Access Compliance Report

Public Rights-of-Way

Intersection ID: 27495	Main Street: BALLANTYNE COMMONS PY	Cross Street: NORTH COMMUNITY HOUSE RD	Location: NW
ADA ID: 41D1354698B1	Ramp Type: Perp	Initial Pass/Fail: Fail	Overall Compliance: No
			Severity Score: 10

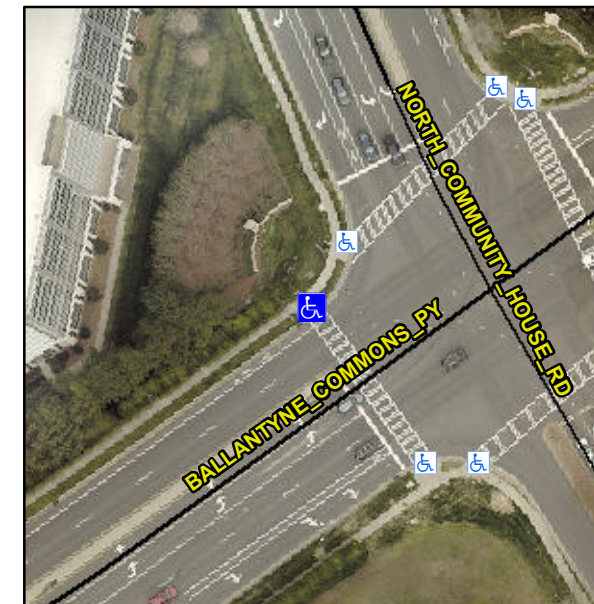
Not Found, R304.5.1

Compliance	Description	Data	Compliance	Description	Data
N/A	Ramp Length (in)	62.0	Yes	Ramp Slope (%)	5.3
No	Ramp Width (in)	47.0	Yes	Ramp XSlope (%)	3.3
N/A	Flare Type LT	N/A	N/A	Flare Type RT	N/A
N/A	Flare Slope LT (%)	N/A	N/A	Flare Slope RT (%)	N/A
N/A	Flare Traversable LT?	N/A	N/A	Flare Traversable RT?	N/A
N/A	Landing Length (in)	N/A	N/A	DWS Provided?	N/A
N/A	Landing Width (in)	N/A	N/A	DWS Contrast?	N/A
N/A	Landing Slope (%)	N/A	N/A	DWS Length (in)	N/A
N/A	Landing X Slope (%)	N/A	N/A	DWS Full Width?	N/A
N/A	Landing Curb? (Y/N)	N/A	N/A	DWS Offset (in)	N/A
N/A	Shared Landing?	N/A			
N/A	Gutter Ponding?	N/A	N/A	Gutter Slope (%)	N/A
N/A	Gutter Lip Ht (in)	N/A	N/A	Gutter X Slope (%)	N/A
N/A	Painted X Walk1?	Yes	N/A	Painted X Walk2?	N/A
	X Walk 1 Direction	To SE		X Walk 2 Direction	N/A
N/A	X Walk 1 Width (in)	124.0	N/A	X Walk 2 Width (in)	N/A
	X Walk 1 Slope (%)	2.5		X Walk 2 Slope (%)	N/A
	X Walk 1 X Slope (%)	3.3		X Walk 2 X Slope (%)	N/A

Remove & Replace Entire Ramp.
